Agnico Eagle Mines Limited – Meadowbank Division

**Whale Tail Pit Groundwater Monitoring Plan
RESPONSES TO REGULATORS REVIEW**

November 9 2018

Figure 1: Conceptual Groundwater Flow between Areas of Open Talik

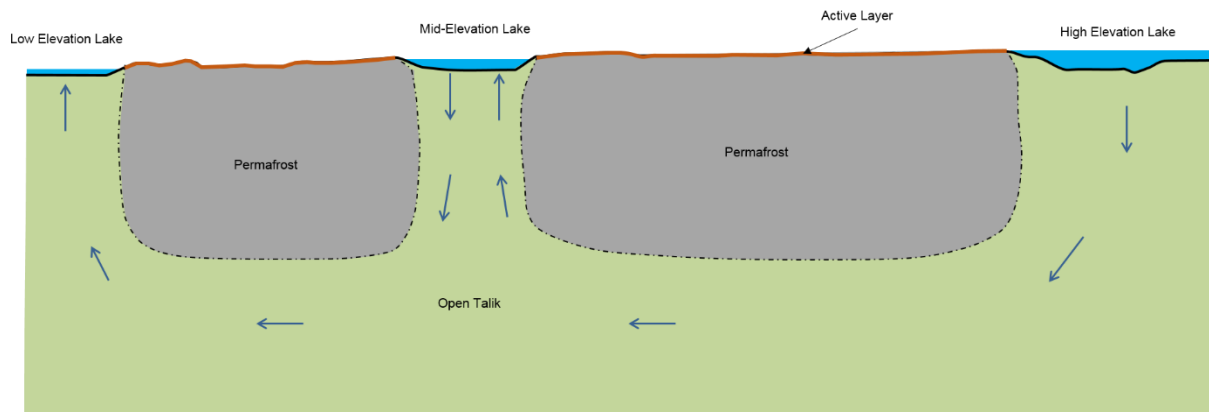
Additionally, CIRNAC was informed on October 17, 2018 that AEM had no plans to install new groundwater monitoring wells and that sampling from the only operational well (Westbay multiport well) at the site was delayed significantly. This information was shared approximately half a year after AEM made its decisions on these issues, without consulting with CIRNAC or others on its intended approach. To ensure more proactive reporting and follow-up on hydrogeological issues, the Groundwater Monitoring Plan should

include provisions for more frequent communication between AEM, CIRNAC and other parties to identify, discuss and address known or potential risks associated with the groundwater regime. Given the short duration of the mine life and the benefits of mitigating emerging concerns as early as possible, we recommend that more frequent communication be held during the operational phase.

- The planned Whale Tail Pit sits within the closed talik below the North Basin of Whale Tail Lake. The closed talik is inferred to transition to open talik below the South Basin due to the increased width and depth of the lake towards the south. The water table below both basins will be equivalent to the lake surface elevation.

- Permafrost underlies the land surrounding the lake, which restricts the lateral flow of groundwater to the talik and restricts the recharge of the sub-permafrost groundwater flow system by precipitation. Groundwater flow is controlled by surface water elevations in lakes with open taliks; water moves vertically through the open talik to the underlying sub-permafrost groundwater flow system. In effect, lakes with open taliks in continuous permafrost regions are equivalent to large monitoring wells. A conceptual image of flow to and from lakes with open taliks is shown on Figure 1.

In summary, Agnico Eagle considers the current data set to provide adequate understanding of baseline conditions for the purposes of assessing environmental effects. Hydraulic head monitoring and groundwater sampling of the Westbay well system will be conducted in November 2018 data will be collected per the Groundwater Monitoring Plan. These data will be used, as required, as input to future updates of the groundwater flow model.
